Re: Wilmington Harbor 403 Draft Letter Report and Environmental Impact Statement,
Wilmington Harbor Navigation Project, North Carolina

**SUPPLEMENTAL COMMENTS SUBMITTED ON BEHALF OF THE VILLAGE OF BALD HEAD ISLAND
REGARDING ECONOMIC ANALYSES:**

Figure 2 Restructuring of Asia/USEC EC2 Service

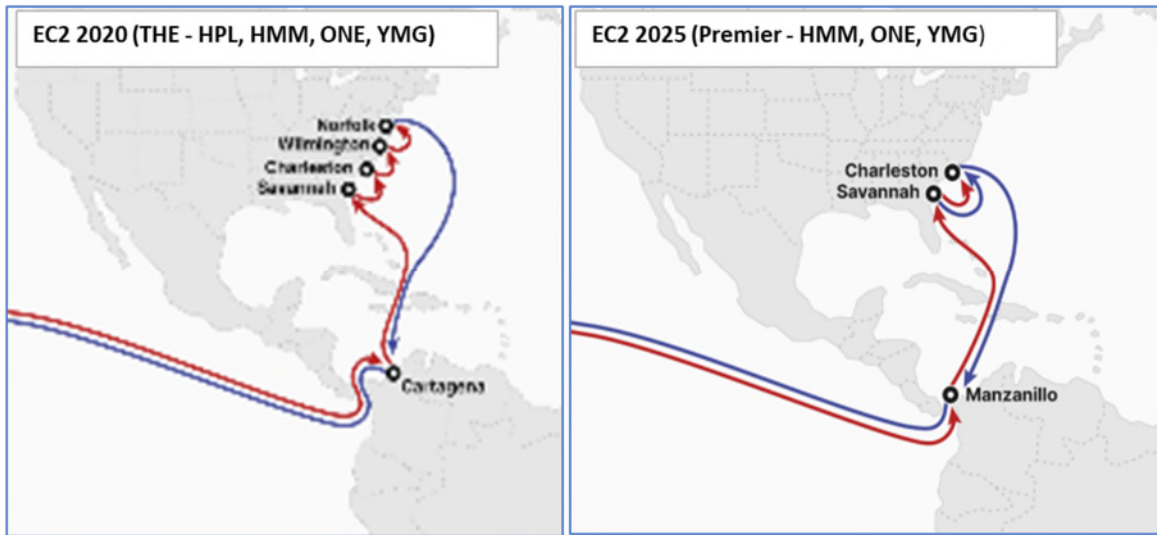
Following the restructuring, the Premier Alliance revised its network of Asian services, including the EC2 service that used to call at Wilmington. The updated EC2’s port rotation dropped Wilmington and Norfolk, following a decline in the Asia/USEC trade route. **Figure 2** shows the route maps of the EC2 Asia/USEC service before and after restructuring. The service pattern of EC2 is through-Panama and it is operated by a mixture of PPX2 & 3 (see Table 9 in Appendix B).

Figure 7 Wilmington's Calls Distribution by PPX Categories

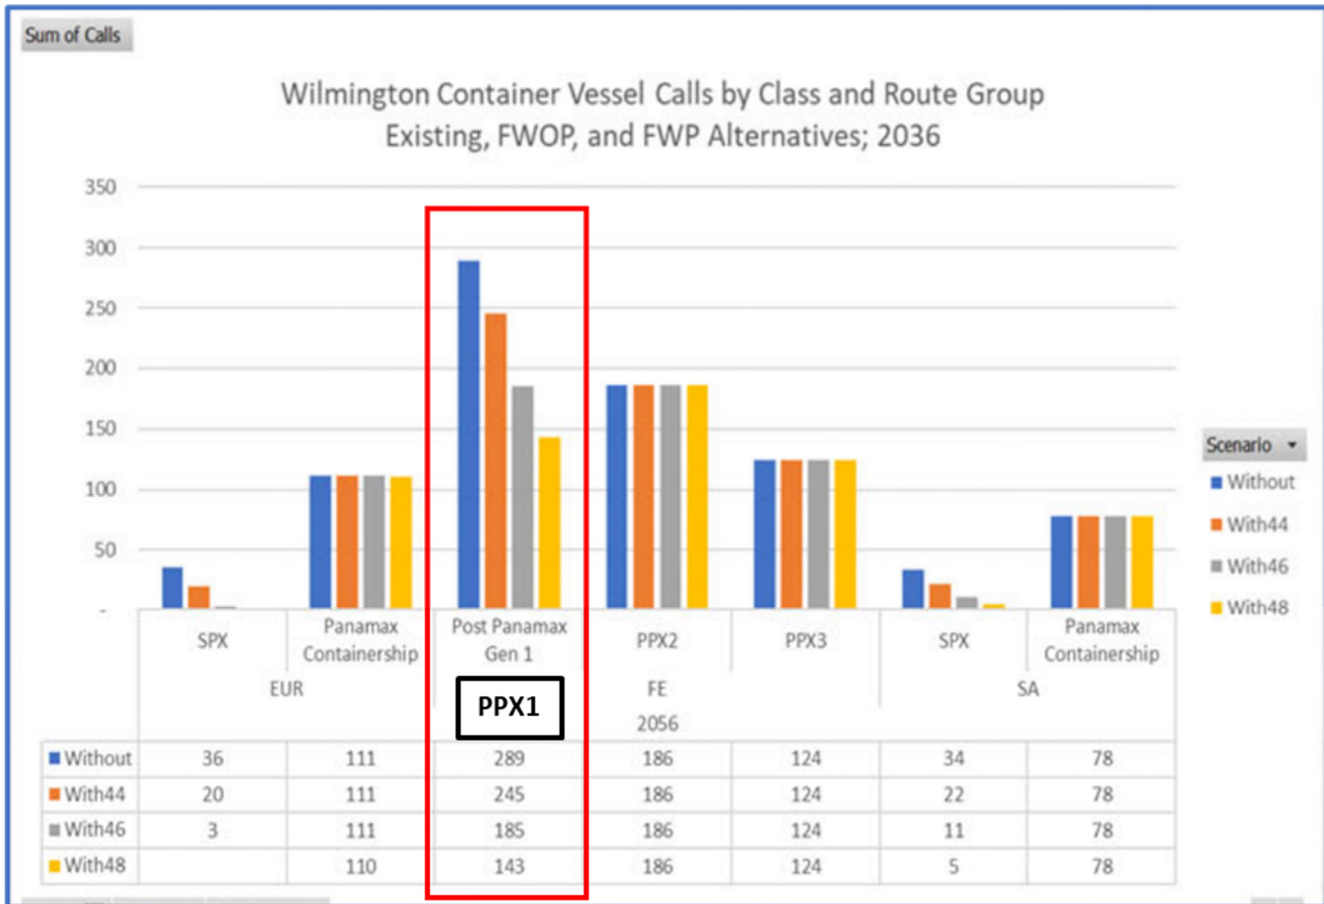
As seen in Table 4 and illustrated in Figure 7, the number of calls of PPX2 & 3 (in red) remained **unchanged**, despite the dramatic, 320% growth in cargo volume (Table 2) and the increase in channel depth in the With cases. **The only change is in the number of calls of PPX1.** It seems, that 2025 EC assumes that PPX1, which already in 2021 became extinct on Asia/USEC services, are expected to re-emerge 15 years later, in 2036 and remain fully deployed even in 2056. To re-emphasize, in 2021, the base year for the 2025 EC report, Wilmington had 2 Asian services: ZCP provided by PPX2 and EC2 PPX3 – **no PPX1**. Moreover, **Figure 8** below, taken from 2020 NCP, p. 29, shows that PPX1 had already become extinct in 2019 (red square).

Figure 10 The "Jump" in Wilmington's Forecast

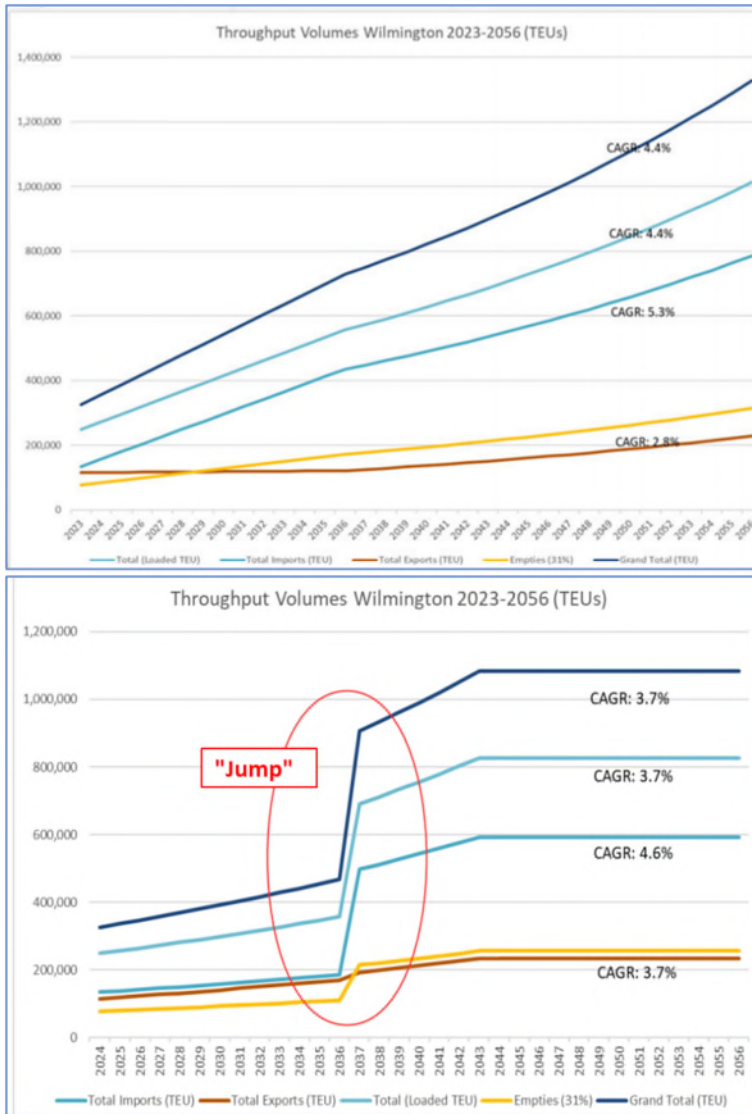
The cargo forecast presented in Table 2, based on Table 5.22 in 2025 EC (p. 35), shows a huge, one-time “jump” in Wilmington’s imports during the 6-year period 2030 – 2036. This jump, which apparently ends right in 2035, the base year of the evaluation of the Project, is quite dramatic; the 2.8 million tons in 2036 is almost 4 times(!) the 0.7 million tons of 2030 (2.8 / 0.7). To facilitate the

The upper part shows gradual and stable growth rates, with no bumps and no jumps, similar to the one presented below for the Port of Oakland in the following Figure 11, and similar to the many USACE channel studies I have reviewed in recent years. The lower part of Figure 8 shows the "jump" (red circle added by me). Interestingly, both charts were prepared and presented in 2024, perhaps by two separate researchers.

As I noted in Section II, 2025 EC does not offer an explanation for the “jump” or the emergence of these 306,000 TEUs, except for indicating, somewhat causally, that it is presumably the result of “\$10 billion investments planned for the next years”. 2025 EC does not provide a list of the planned, new or expanded, local industries, and for each an estimate of tonnage and TEUs projections for each. There is also no reference to studies that discuss and explain this unusual growth in imports. In this appendix, I attempt to provide my own, although rough, estimate of Wilmington’s expected growth in Asian imports, resulting from the above-mentioned investments.

Figure 11 Cargo Forecast for the Port of Oakland

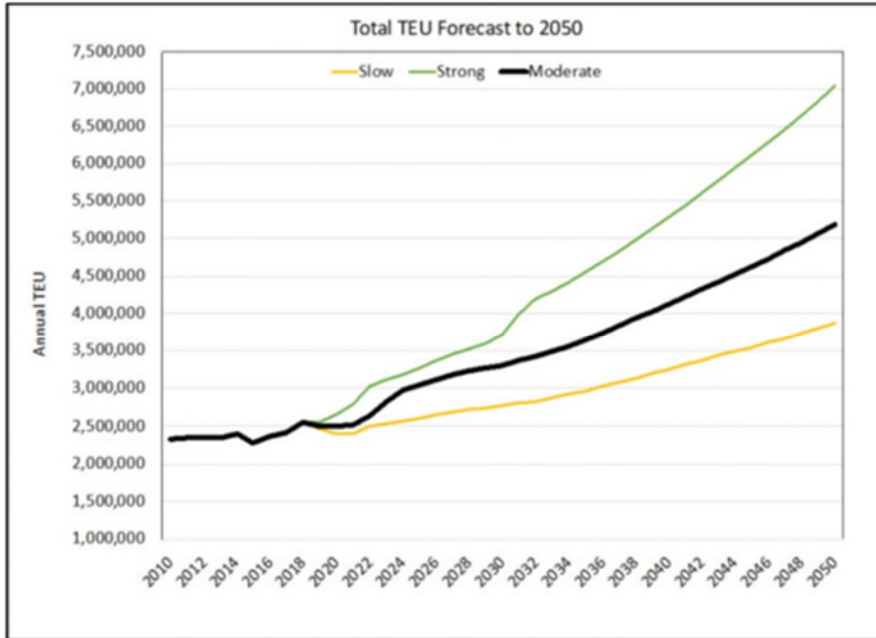
Figure 11 shows the Port of Oakland's forecast for 40 years, taken for USACE study of Oakland, CA. This figure shows steady growth rates similar also for a USWC port. Why does 2025 EC apply a different forecasting methodology to Wilmington?

In both Table 8 and Figure 11, the forecast includes 3 growth scenarios, low, moderate and high. This also is the case in Figure 10, upper part, that shows Wilmington’s forecasts in 2024 PowerPoint. However, 2025 EC provides **only one scenario**, presumably the moderate growth, with no explanation given. As will be seen in the following sections devoted to a discussion of the specifics of the “jump”, there also are no scenarios there. It seems that this avoidance of scenario-based assessment is in line with the overall analytical approach of 2025 EC, which for unknown reasons excludes sensitivity testing of its assumptions.

Figure 12 World Fleet by PPX Categories

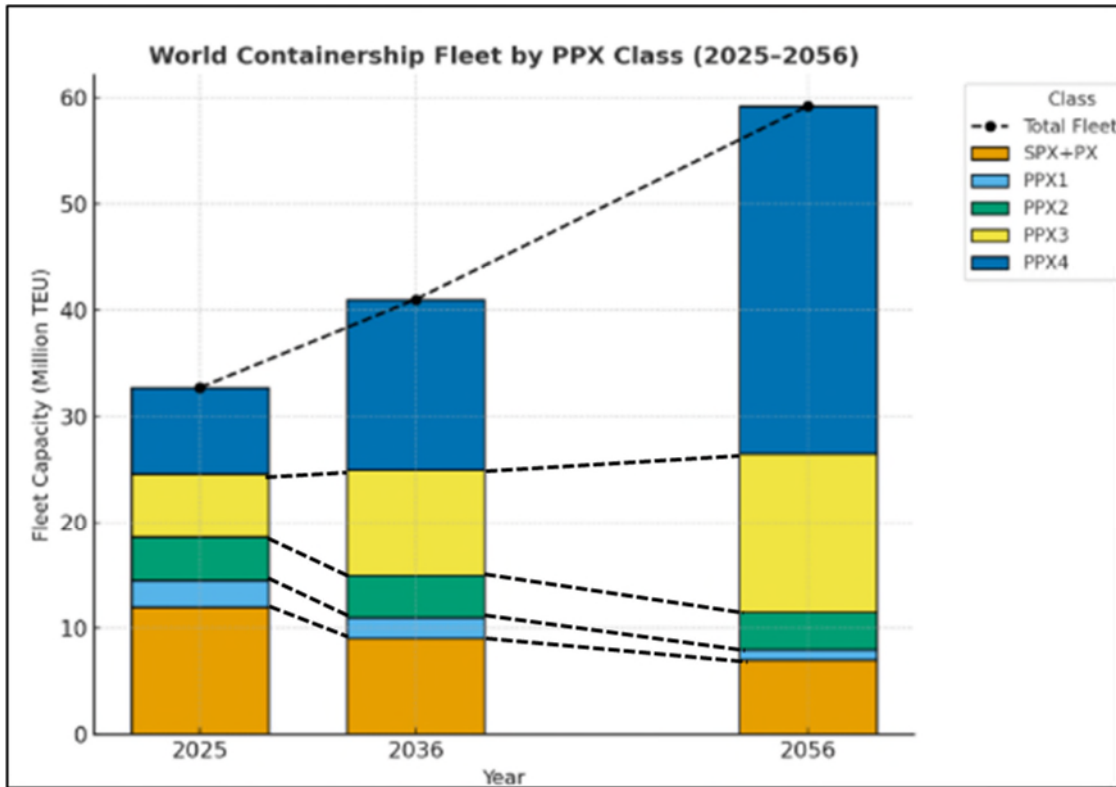
As seen in Figure 12, PPX1, the dominant vessel in 2025 EC, and the main source of savings due to the predicted reduction in the number of calls, is bound to almost disappear. The largest category of the PPX in 2025, PPX3, is expected to further grow, while PPX2 remains unchanged. Another trend is the tremendous growth in PPX4. These 24,000-TEU vessels, already dominating the Asia/Europe trade are likely, eventually (2036?), following the next round of USEC-ports' deepening, to also dominate Asia/USEC services, which by then will mostly be through-Suez.

How can one predict the reappearance of PPX1-based services in 2036, when most of them are already bygone as seen in Figure 12?

Another hurdle for such a service is a severe shortage in PPX1. As seen in Figure 12 above, the availability of smaller PPXs will sharply decline in the future. The reason is simple, there is and will be a limited worldwide use for this historical, small-capacity vessel design.
